**ADDENDUM NO. 3**  
**GRANGER PARK**  
**CITY OF LAGRANGE**  
**LAGRANGE, GEORGIA**

## QUESTIONS AND RESPONSES

### GRANGER PARK

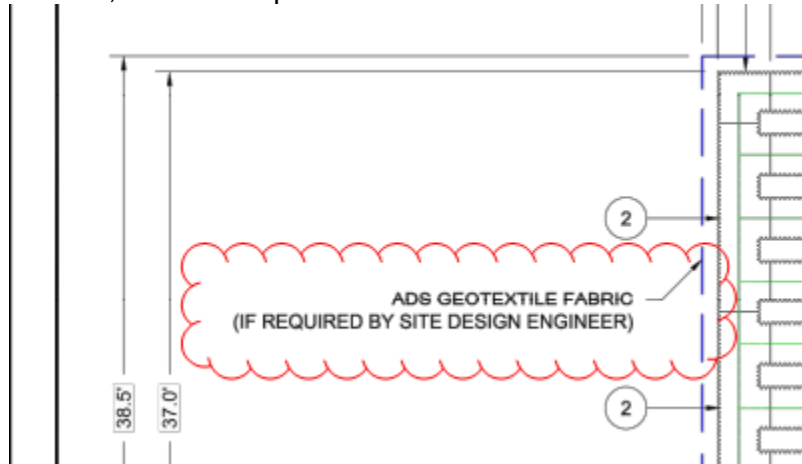
**Question 1:** On drawing L1.01, there are two references to detail L/3.00. One arrow points to a sidewalk and the other to an area that is next to an “Open Lawn Area”.

I’m having trouble differentiating between what is the lawn area and what is the Root Bridge Paving area. Is the arrow that points to a sidewalk in error?

**Answer 1:** The Root Bridge label closer to the top of the page is incorrect. That arrow should point to the hatched area within the oval trike path – the hatch indicated designated root bridge zone. The Root Bridge label lower on the page is correct and pointing to the hatched area within the sidewalk that is running east / west.
